OFFICIAL COORDINATION REQUEST FOR NON-ROUTINE OPERATIONS AND MAINTENANCE

COORDINATION TITLE- 21 IHR 15 – Unit 2 special generator testing

PROJECT- Ice Harbor Dam

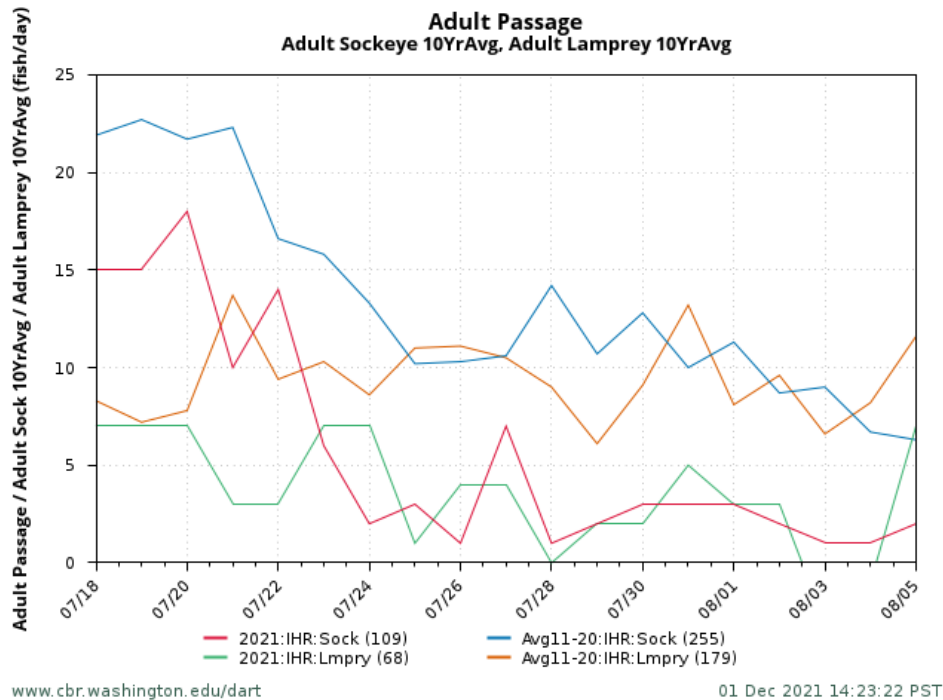
As shown in the graphs above, total adult fish passage at the dam (past the count windows) is relatively low during the proposed work period. Steelhead numbers usually slowly start to rise in August. Sockeye numbers usually start declining in the middle of July. Lamprey are passing during the proposed period, with an average of 13 or fewer lamprey counted per day. The 10-year average total of bull trout counted during that period is 0 fish.
